SEEGER HOMES INC. - SALES OFFICE

SITE DEVELOPMENT PLANS  
LOT 3, APPALOOSA HIGHWAY 24 SUBDIVISION

SALES OFFICE - SPECIAL USE  
DEVELOPMENT PLAN

SHEET NO:  
C-01  
DATE:  
05/25/18  
PAGE NO:  
1 OF 1

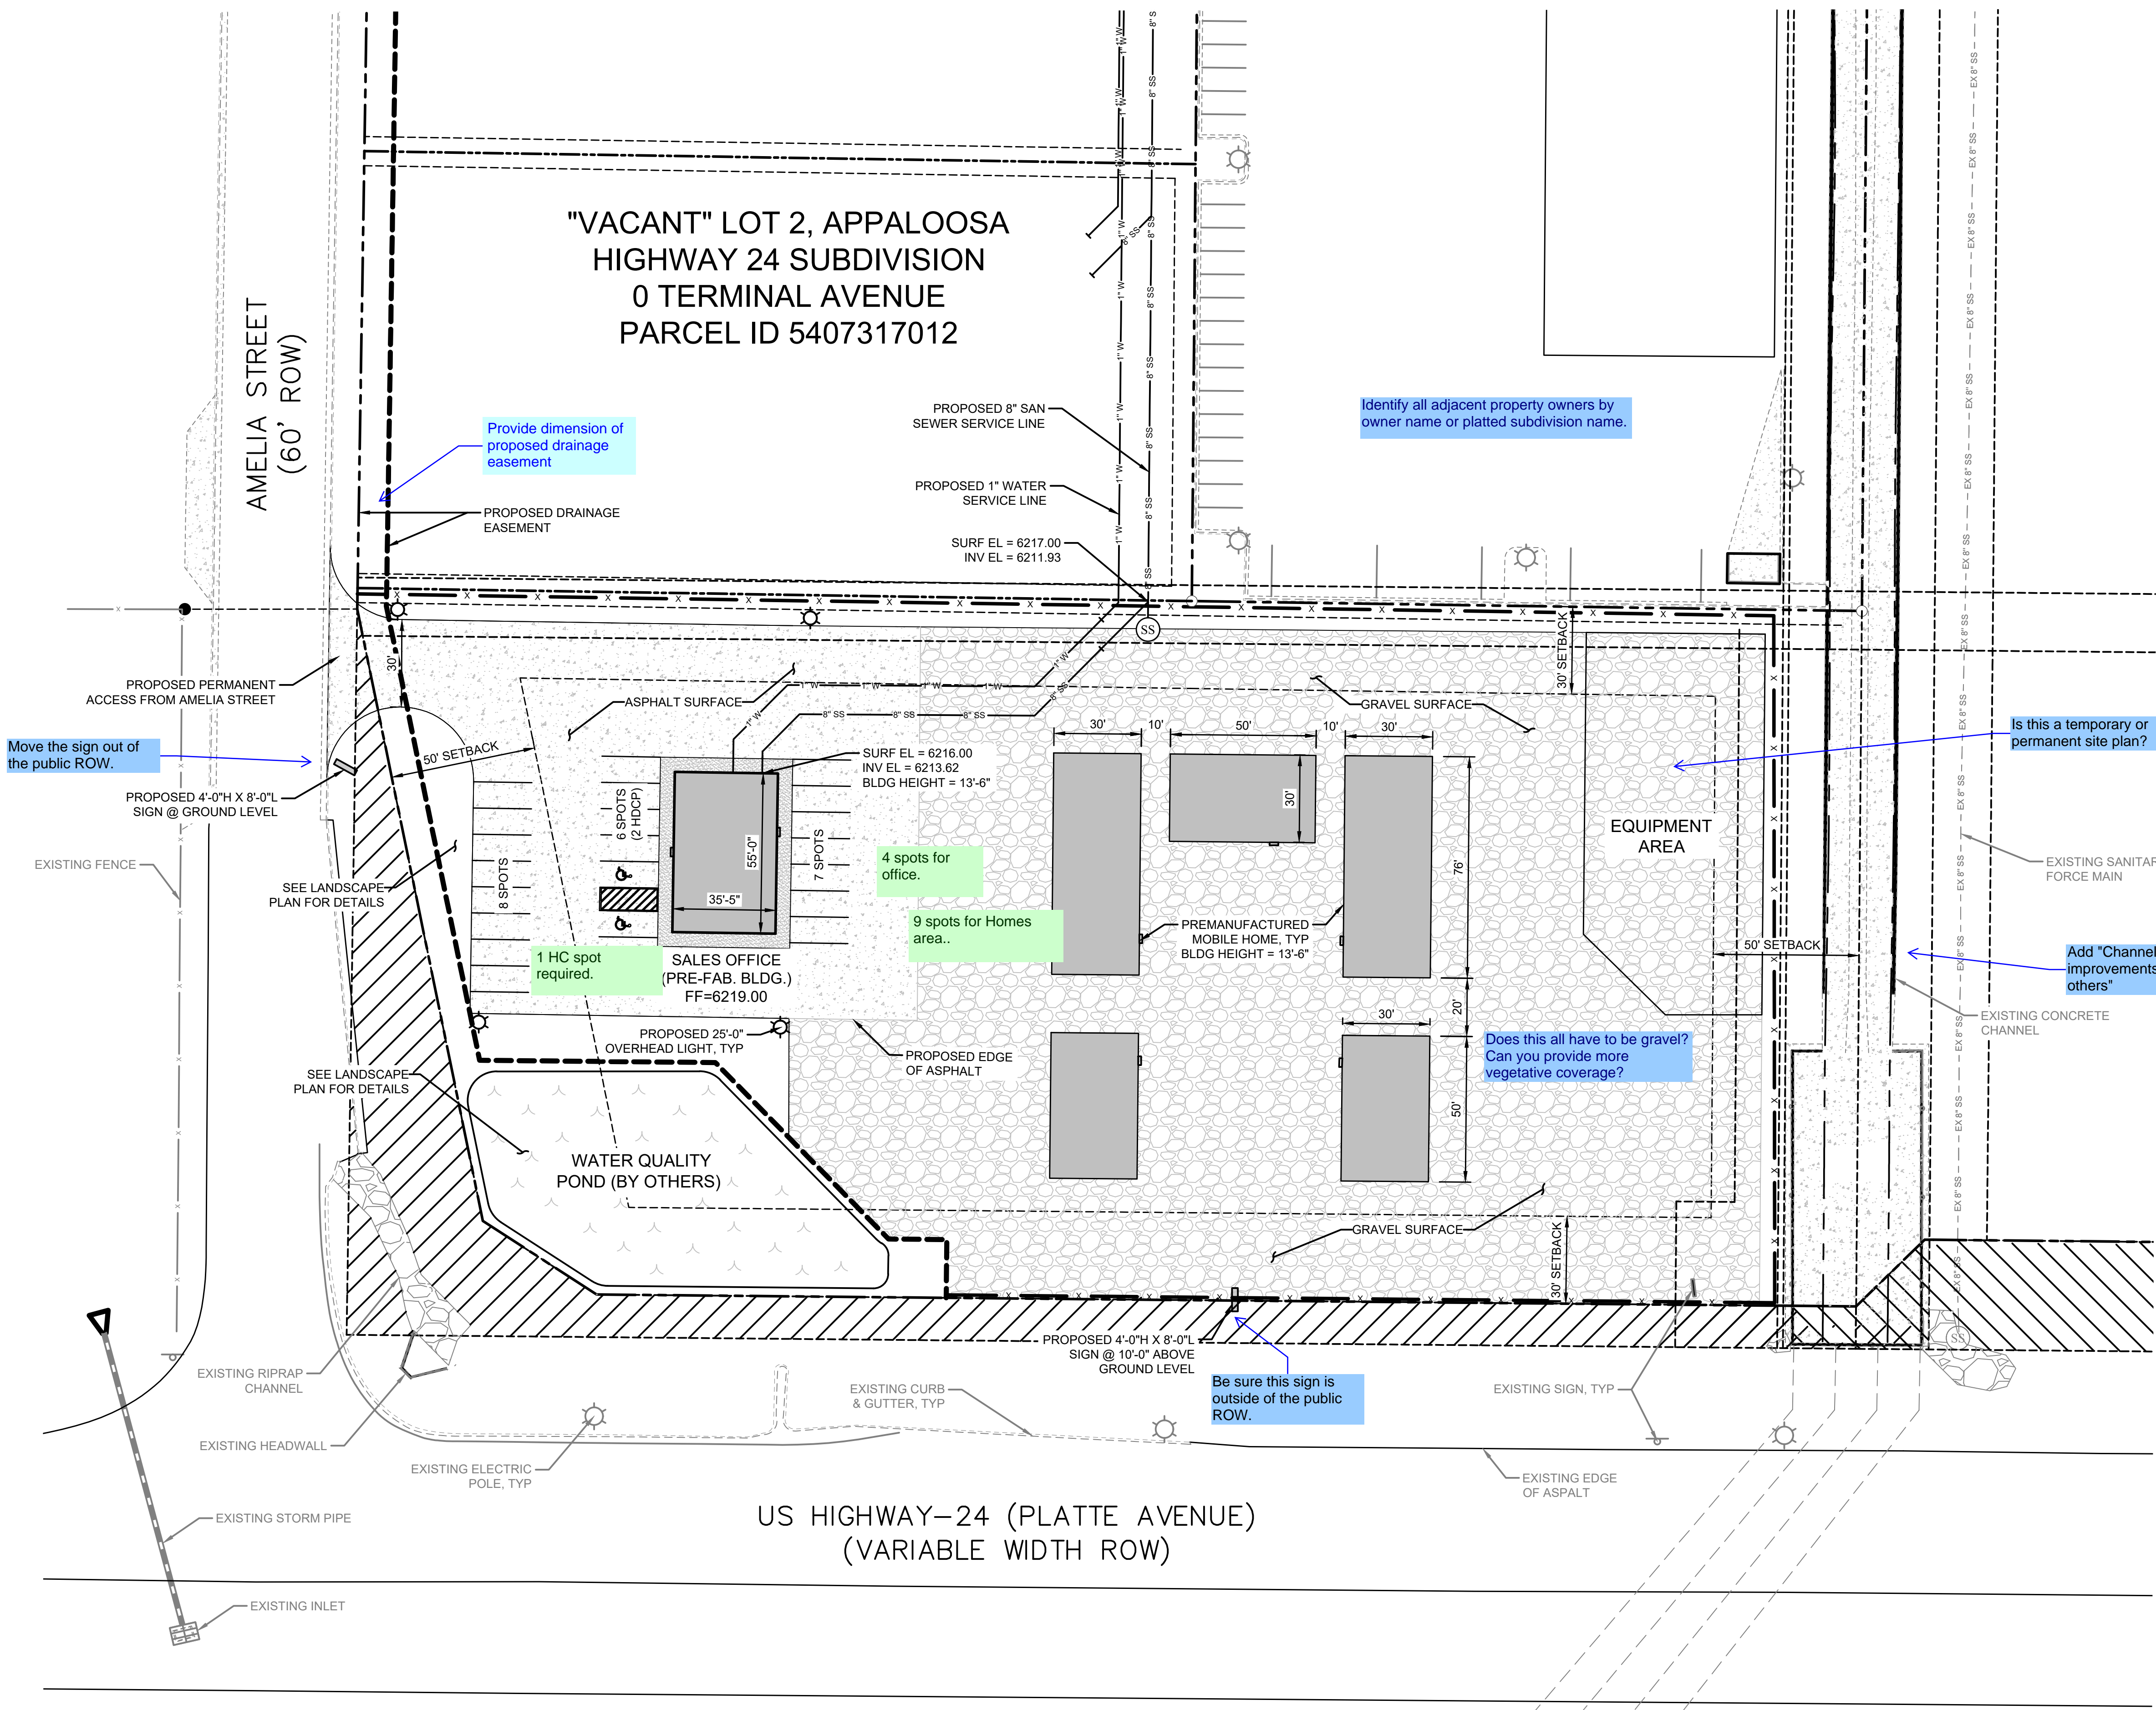
Driveway access permit will be required.  
Application form is available at the PCD front desk

Provide legend for various line types used on the plan

Is this a temporary or permanent site plan?

Add "Channel improvements by others"

Does this all have to be gravel?  
Can you provide more vegetative coverage?

Be sure this sign is outside of the public ROW.

Add PCD File No. PPR1831

Provide dimension of proposed drainage  
easement

Move the sign out of the public ROW.

Identify all adjacent property owners by owner name or platted subdivision name.

4 spots for office.

9 spots for Homes area..

1 HC spot required.
